INSURANCE INSTITUTE FOR HIGHWAY SAFETY

**Notice of Proposed Rulemaking
Federal Motor Vehicle Safety Standards; Side Impact Protection;
Side Impact Phase-In Reporting Requirements
Docket No. NHTSA-2004-17694**

Figure A-1 - Top and Side Cross-Sectional Views of FMVSS 214 (left) and IIHS (right) Barriers; All Measurements are in Millimeters

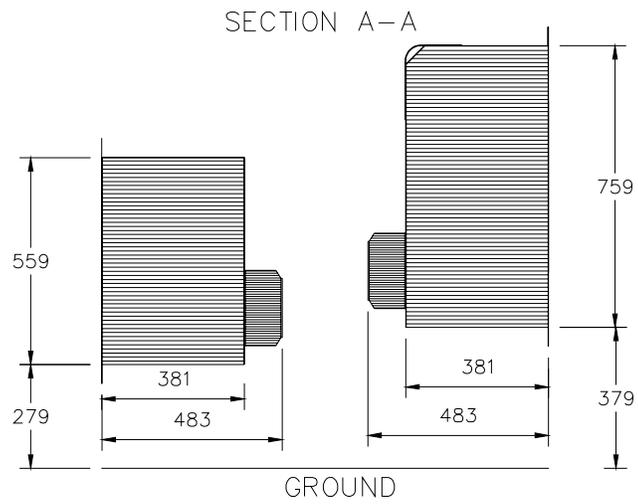
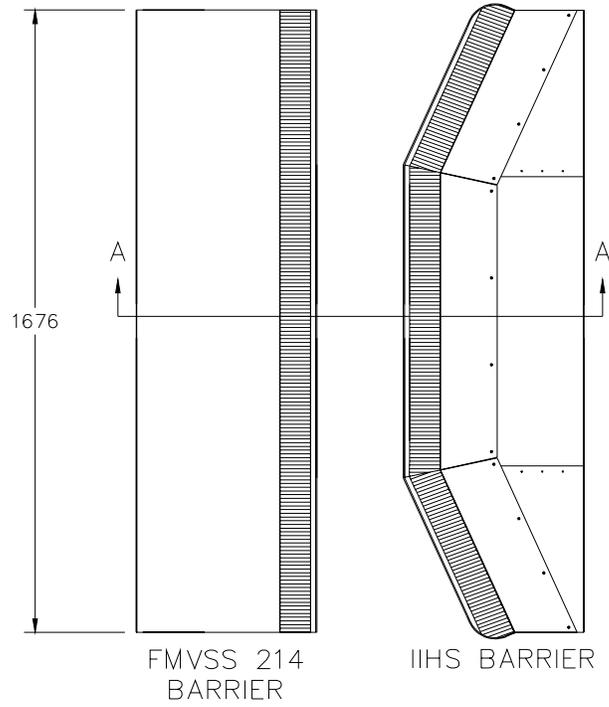
The IIHS barrier design is based on the FMVSS 214 barrier, but it is raised 10 cm from the ground and made 20 cm taller; this makes the IIHS barrier's top surface 30 cm higher than that of the FMVSS 214 barrier. The ride height of the IIHS barrier's bumper element is aligned closely with the lower edges of SUV and pickup bumpers measured at the time the IIHS barrier was designed (Arbelaez et al., 2002a). In addition to the changes made to the side view of the IIHS barrier, the front profile was contoured in the overhead view with simple 24.5-degree chamfers to represent the curved bumper geometry observed in the SUVs and pickups. A side-by-side illustration of the FMVSS 214 and IIHS barriers is shown in Appendix A, Figure A-1.

Although the stiffness characteristics of the deformable element used in the IIHS barrier are identical to those used in the FMVSS 214 barrier, vehicles tested with these two barriers respond very differently. The FMVSS 214 barrier's lower ride height allows it to engage the door sill structure of the struck vehicle, and the flat front-end profile of the barrier engages the A- and C-pillar structures earlier in the crash. Because the IIHS barrier has a higher ride height and a contoured overhead profile, the primary load path on the struck vehicle is the B-pillar. There is more door intrusion, and the higher intruding barrier face poses a significant risk to the heads of occupants in the struck vehicle. During the past two years, IIHS has seen considerable improvements by some manufacturers in stiffening B-pillar structures along with roof rails and door sills. By continuing to use the current FMVSS 214 barrier, NHTSA will not be driving these improvements in structural designs that can benefit occupants in real-world side crashes.

Because of this widespread acceptance and because the IIHS barrier better reflects the types of vehicles increasingly likely to cause serious injury in side impact collisions, we urge the agency to replace the now long out-of-date NHTSA MDB with the IIHS barrier for this rule. Rarely does such an opportunity for harmonized advancement of vehicle testing standards present itself. If the agency does not take this opportunity to improve the barrier and if it decides to accept less biofidelic dummy options (discussed next), it is difficult to see what benefits will accrue from the additional MDB tests that have been proposed.
